CHRYSLER A604 COOLER BYPASS CHECK VALVE ADDED TO CASE

CHANGE: Beginning in 1991 model A604 transaxles, there has been a "Cooler Bypass Check Valve

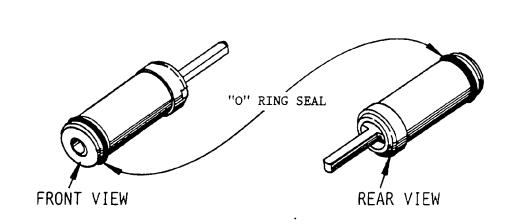
(1) COOLER BYPASS CHECK VALVE - added into the case cooler passage behind the oil pump (See Figure 2). If cooler oil flow is restricted, or blocked, the new check valve will open, and allow cooler feed oil direct into the lube circuit to prevent transaxle damage. Normal operation is resumed after oil temperature is warm enough to again flow through the cooler. (See Figure 1).

Figure 2
AUTOMATIC TRANSMISSION SERVICE GROUP

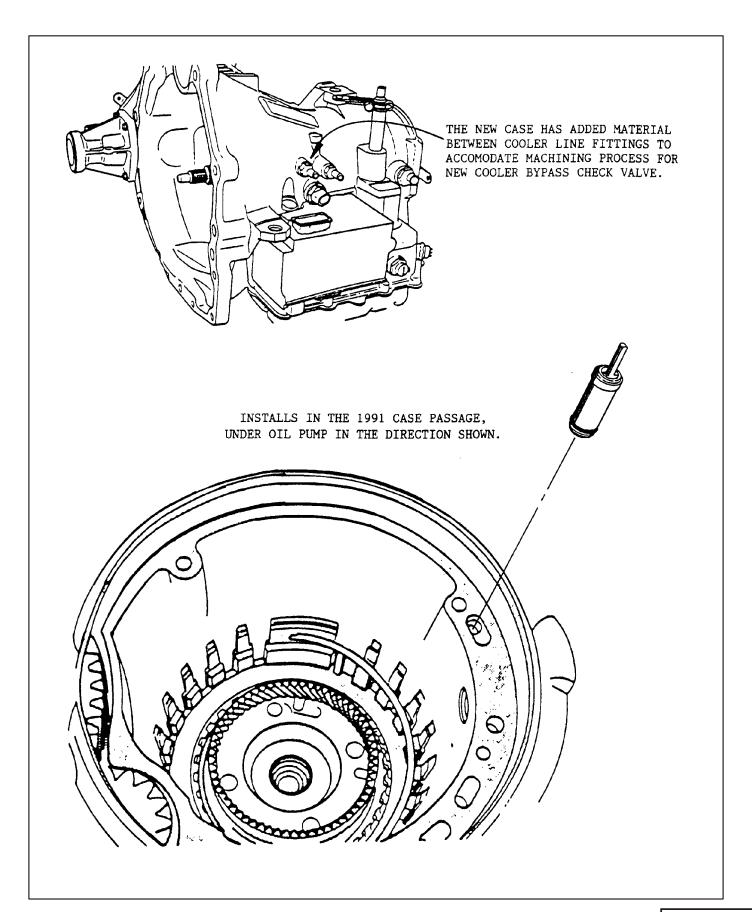
- (2) **TRANSAXLE CASE** The new case has added material between the two cooler line fittings, to accommodate the machining process needed for the new cooler bypass check valve assembly (See Figure 2).
- (3) VALVE BODY SPACER PLATE Lube feed hole in spacer plate has been enlarged to .112", as shown in Figure 3.
